<h1 style="margin: 0;">VOLVO</h1> <h2 style="margin: 0;">Service Manager Bulletin</h2>				TITLE: Recall 214: Engine Cooling Fan Module		GROUP: 26	NO: 214
				MODEL YEAR 2008 & 2009 S80, V70, XC70		ISSUING DEPARTMENT: Warranty	
REFERENCE BULLETINS: PB 26-214 RTJ 21201		CAR MARKET: United States, Canada					
		DATE: YEAR MONTH DAY 2009 06 08		Page 1 of 4			
Service Person- nel: read and initial.	SERVICE MANAGER			SERVICE WRITER	WARRANTY ADMINISTRATOR

Retailer Technical Journal 21201

Recall 214: Cooling fan control module, Replacement

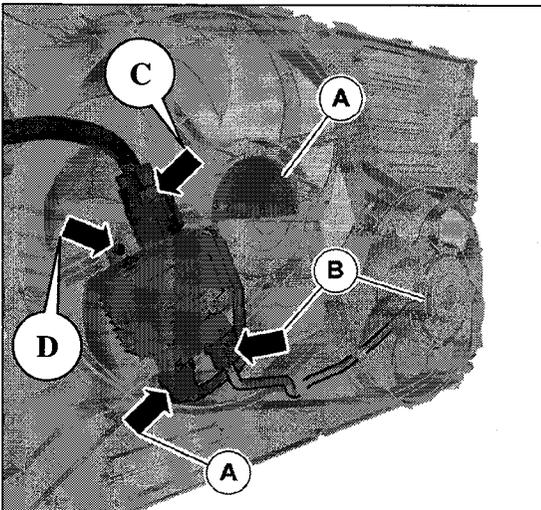
4. Circled notes A & B show the fan harnesses and their respective fans. Disconnect the harnesses and hang them to one side.

Disconnect the fan control module connector at circled note C and remove screw at circled note D.
